RENESAS TECHNICAL UPDATE

Product Category	MPU&MCU	Document No.	TN-740-A108A/E	Rev.	1.00
Title	Additional Information to 7542 Group Datasheet		Information Category	Technical Notification	
Applicable Product	7542 Group Flash memory version	Lot No.	Reference Document	7542 Group Datasheet	
		All lots

Figure 1 Time delay from suspend request until erase suspend

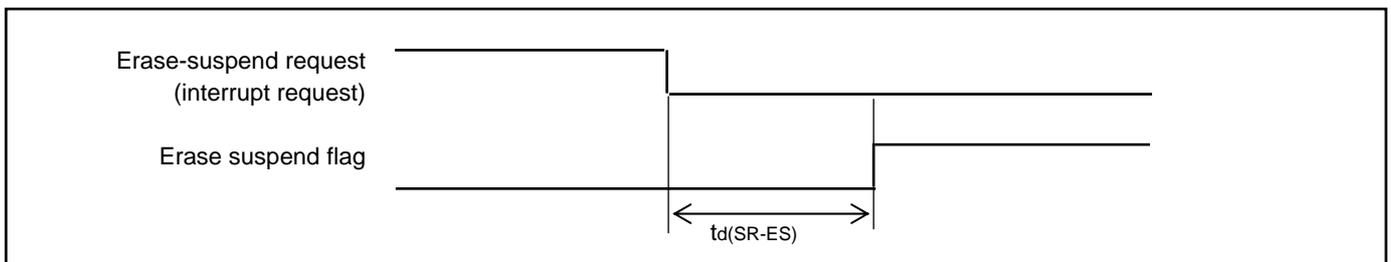
We are going to add the Electrical characteristics of the 7542 Group Flash Memory to the 7542 Group Datasheet.
When using the 7542 Group Datasheet, please note this information.
